Pre-Application Meeting PRE 23-20 Follow-up Notes

Tuesday, November 7, 2023 at 10:00 a.m.

Thank you for joining staff for pre-application meeting PRE 23-20 to discuss the proposal by Immanuel Lutheran Church for annexation, rezoning to Nodal Single Family Residential (RSN), partition, and planned unit development (PUD) of approximately 8.10 acres with no street address ([Tax Lot 052W130000301](#)) at the southeast corner of Evergreen Road & Linfield Avenue into a church with accessory uses, including non-profit commercial offices in an outbuilding, on a northwest lot of approximately 4.4 acres, providing a southwest tract of improved common area / open space of approximately 1.7 acres, and leaving approximately 2 acres undeveloped as an east lot.

MONTEBELLO 3

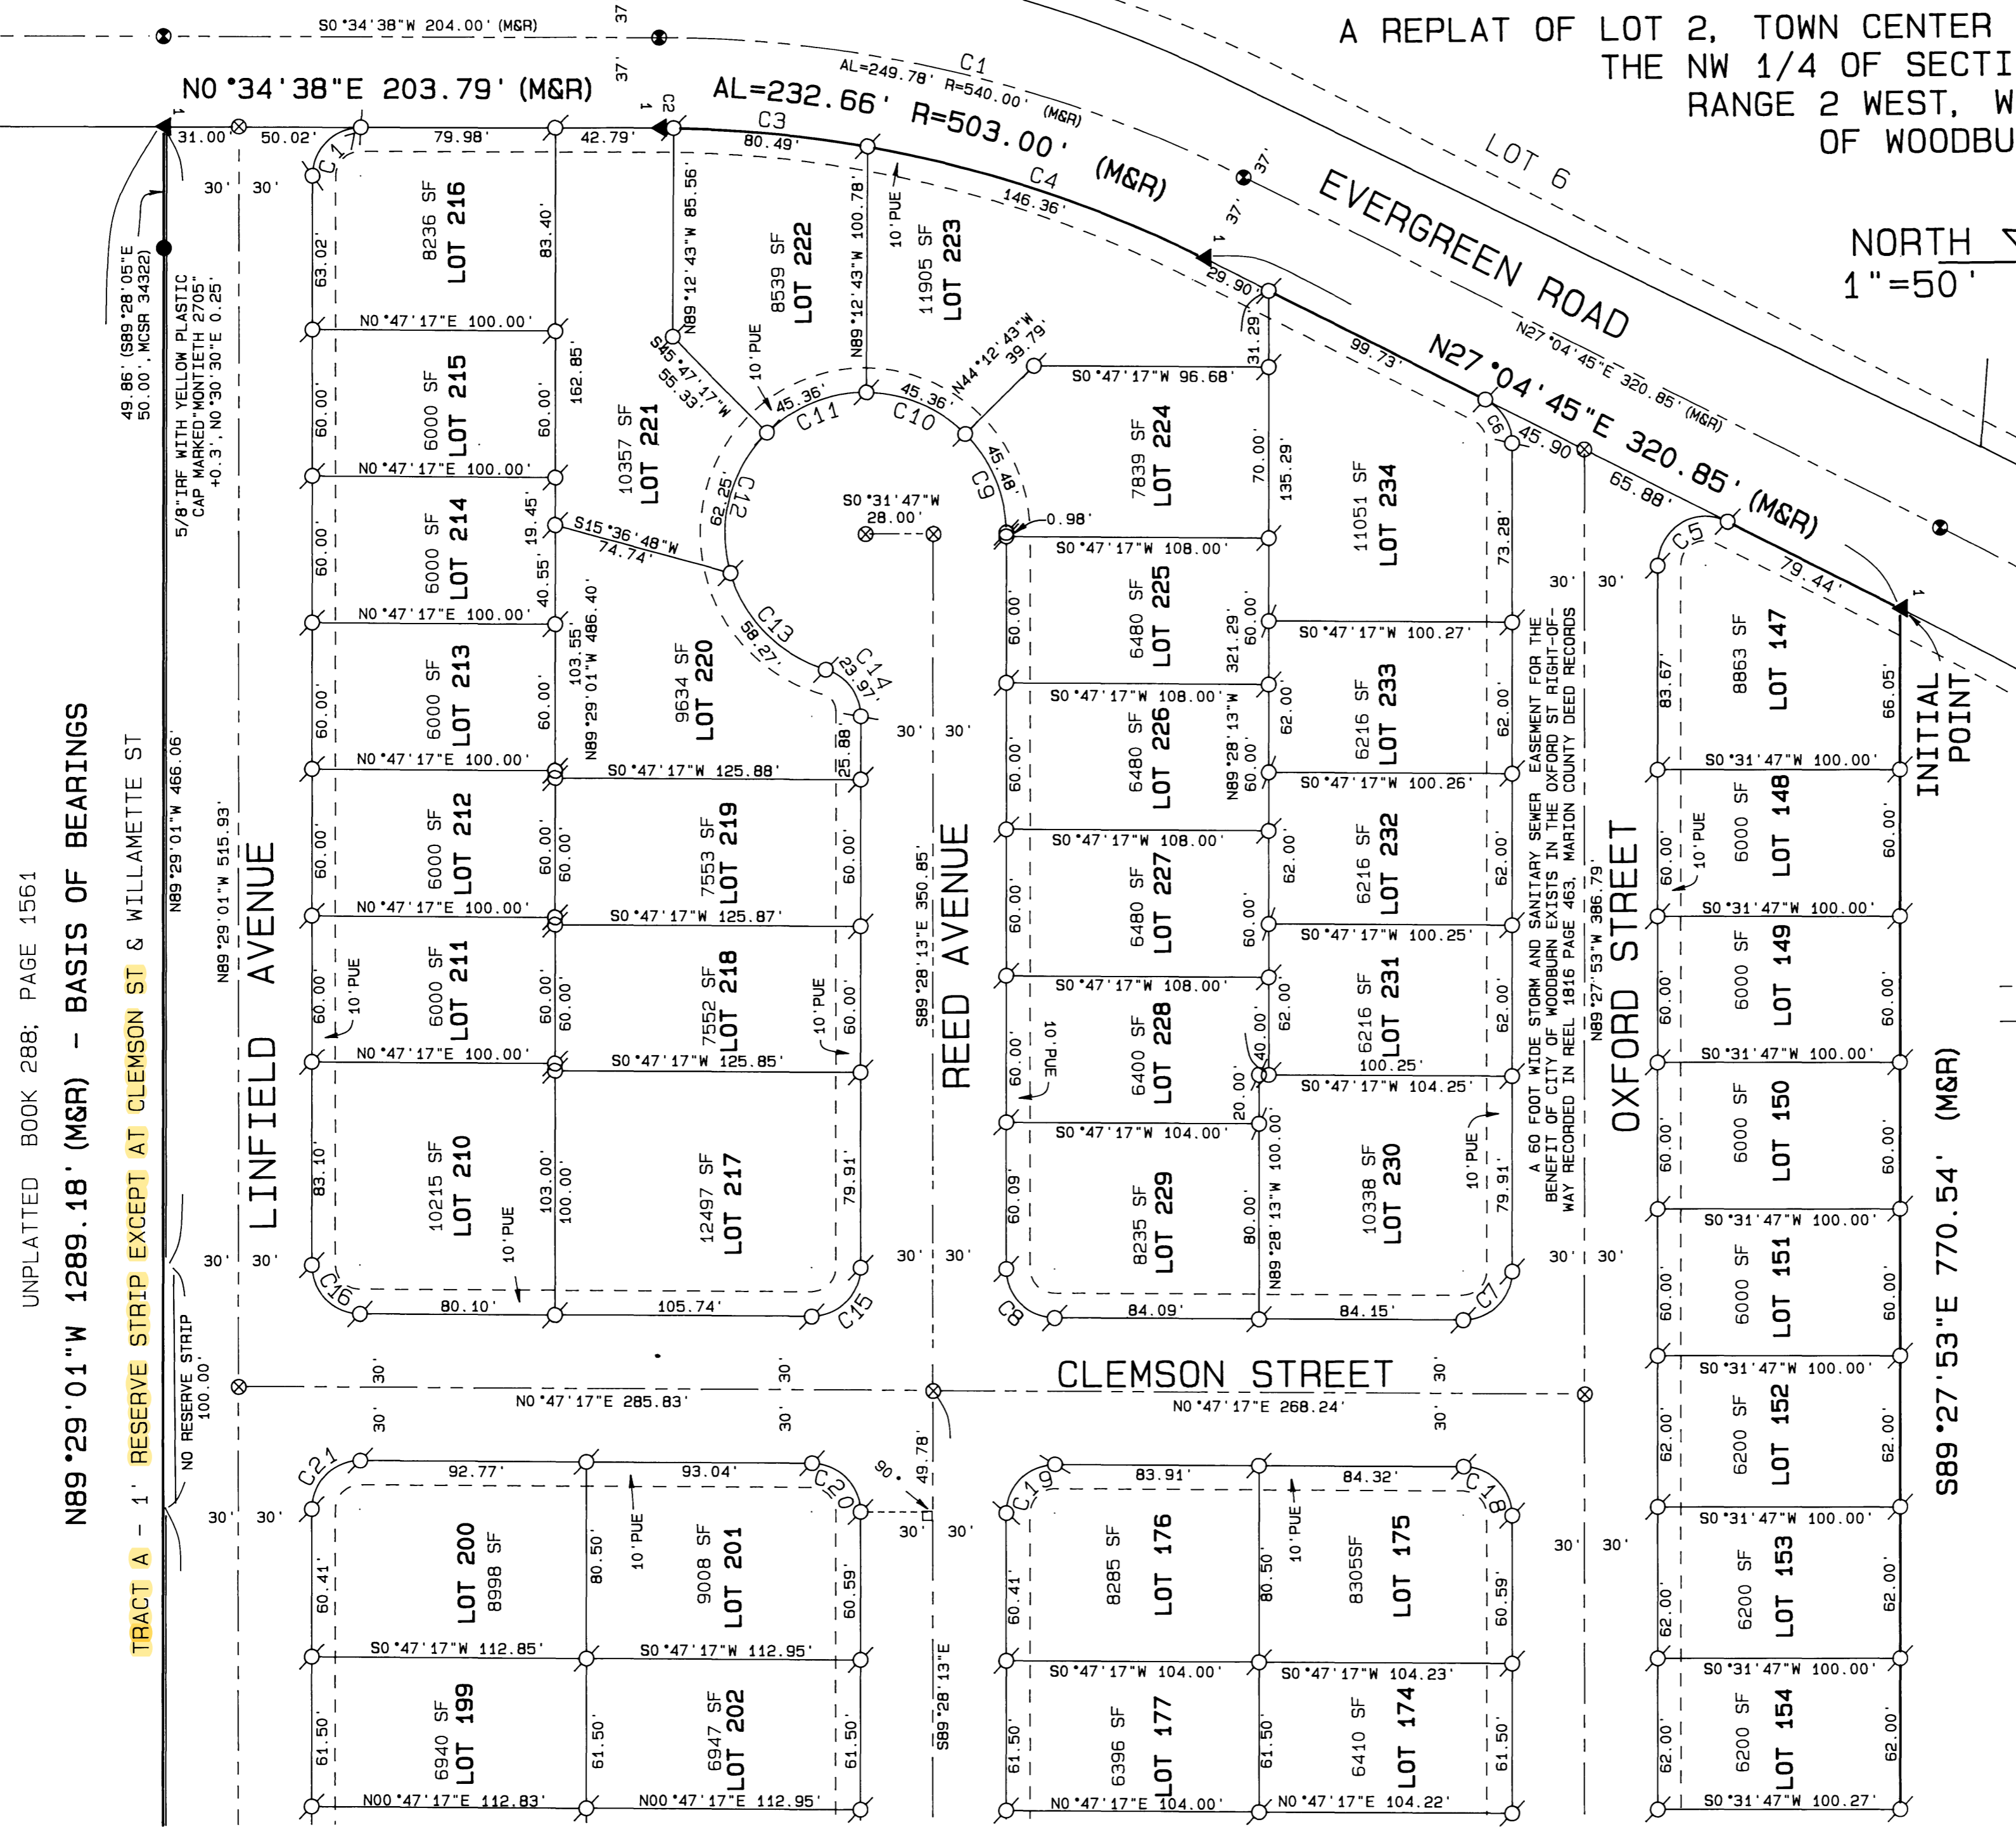
2. Driveway numbers and placements / access management:
 - a. Because what staff informally calls a “spite strip” exists along the south side of Linfield, with only one gap along the territory to be annexed – at Clemson – the proposed easternmost driveway along Linfield is precluded. (See attached Plat of Montebello 3 subdivision, Page 1 from County record H46-72 dated 2007.)

1 Plan: Proposed Site Development
 A1.1 Scale: 1" = 30'-0"

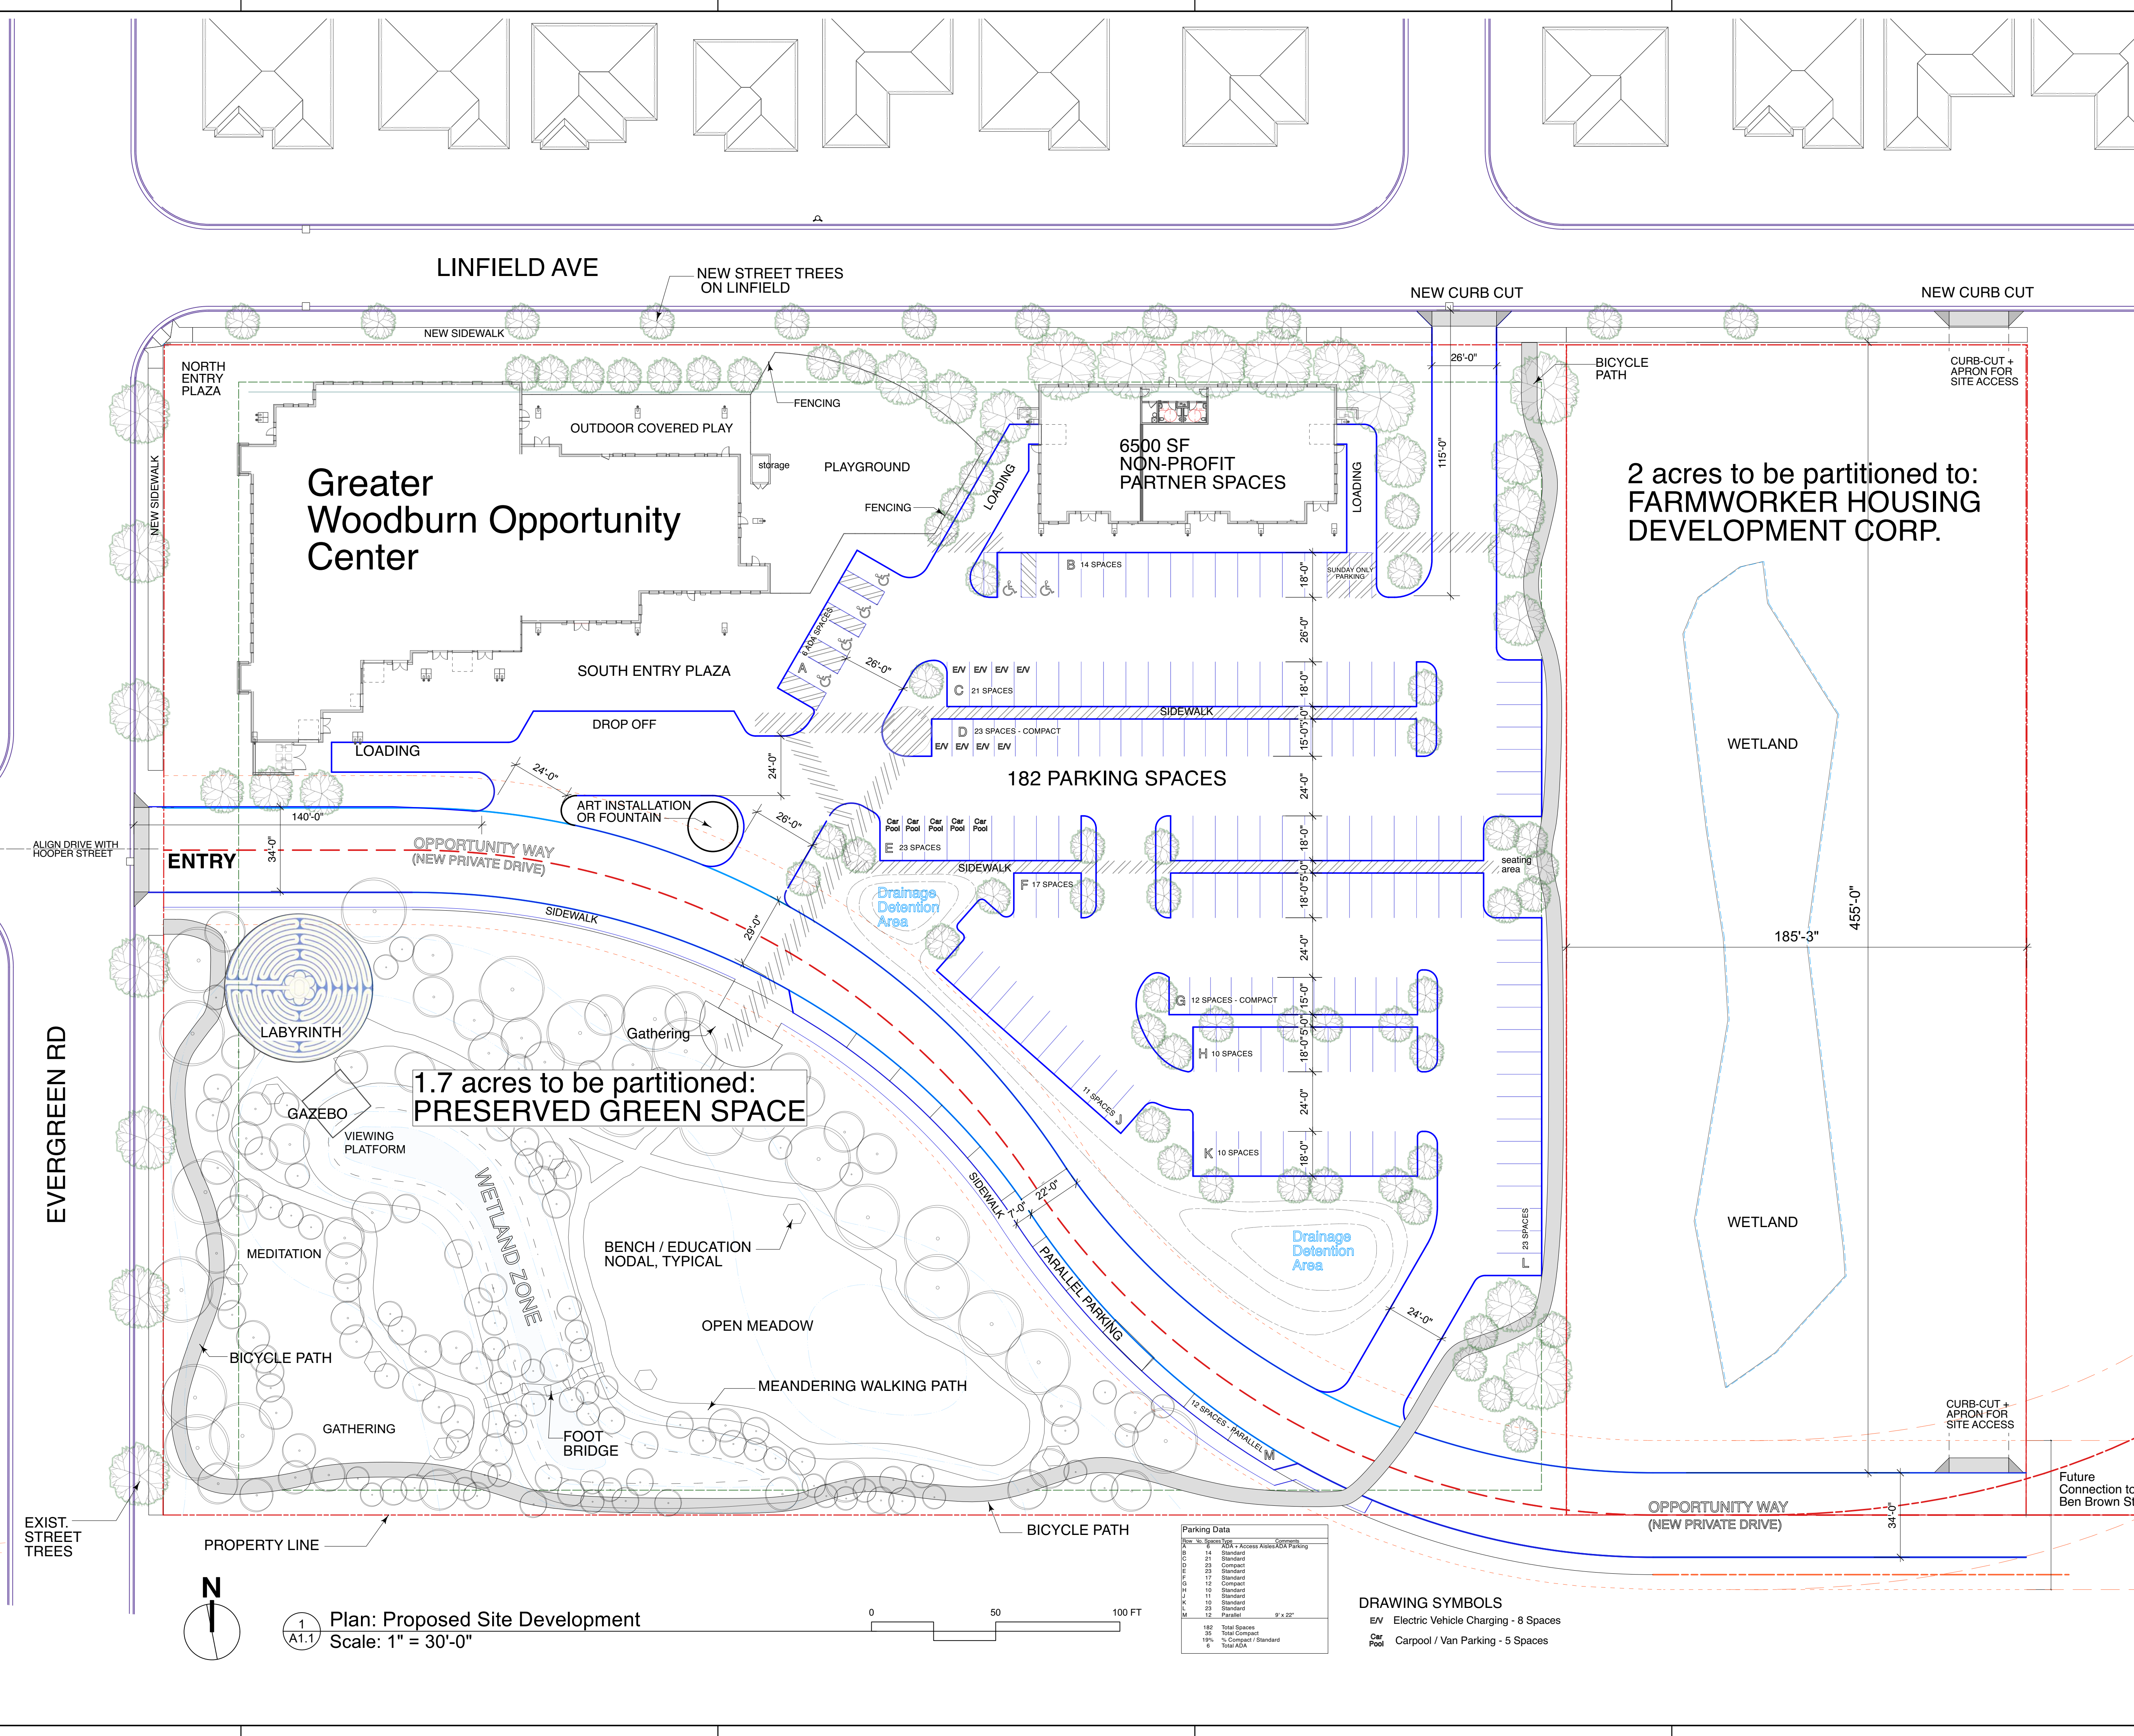
Revise the site plans to provide extensions of Ben Brown Drive to the east property line approximately 180-200 feet (ft) south of Linfield right-of-way (ROW; equal to two house lots depth) and of Clemson Street to the south property line.

- I. Site plan feedback:
1. Regarding streetside public utility easements (PUEs) for which per 3.02.01B min width is 5 ft and maximum (max) is 8 ft, delineate and label or call-out PUEs on the site plans, for purpose of demonstrating intended conformance (through partition recordation to come). If plan sets are affiliated by app type, then at least for annexation, partition, and site development. For site development, at least the general site plan, the composite utility plan, individual utility plan sheets, and the landscape plan.

- b. Reduce Ben Brown Drive north side driveways from 3 to 2; or, revise the drop-off driveway to one-way outbound only at 12 ft width. (3.04.03B.3 & 5; 3.04.03C.1 & 2)

- 3. Driveway max width: For any proposed driveway to be 26 ft wide, exceeding the max width of 24 ft per Table 3.04A where two-way and no left turn pocket, expect to note on the site plan and supplement with documentation from the Woodburn Fire District allowing developer use of table footnote 7.

- 4. Wheel stops are required in all spaces facing wide walkways and to prevent projecting over walkways so as to leave less than 4.5 feet of unobstructed passage, per 3.05.02H. Symbolize on the site plans.

- 5. Parking space double striping is required per 3.05.02K as Figure 3.05C illustrates. Note on the site plans.
- 6. Have the site plan (and narrative) note the land uses from parking Table 3.05A and tabulate the corresponding minimum parking ratios and calculations yielding subtotals and total.

- 7. Max of 9 or 10 parking spaces in a row, depending: Revision needed to conform with 3.06.03C.3.
- 8. Tables 3.05C-E about carpool/vanpool (C/V), bicycle, and electric vehicle (EV) are unclear about how they are applicable to non-residential development within a residential zoning district. Staff interprets that they be applicable as follows:
